Access Compliance Report Public Rights-of-Way (Curb Ramps)

Main Street: N/A		Cross Street: ESENCIA_DR		Location:	NE
ADA ID: RPAT220125112513	Ramp Type: Type 6 - Directional 1	Initial Pass/Fail: Fail	Overall Compliance: No	Severity Score:	15
Codes/Mitigation Info/Possible Solution			Field Measurements/Component Compliance

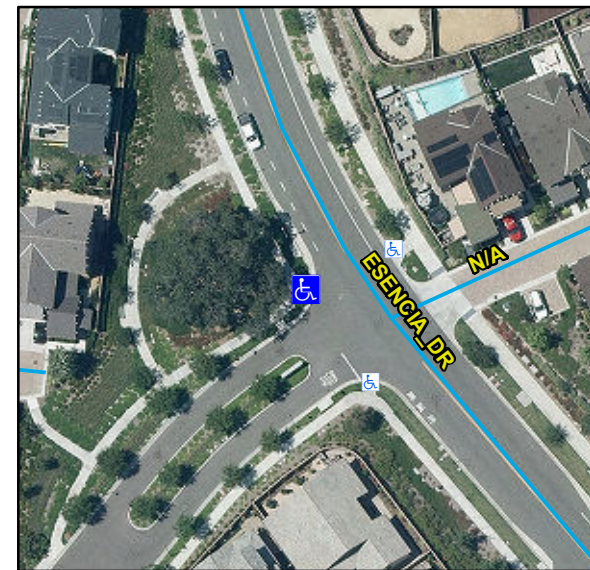
R304.2.2, STD 1115

Remove & Replace Curb Ramp With Two New Directional Ramps or Equivalent.
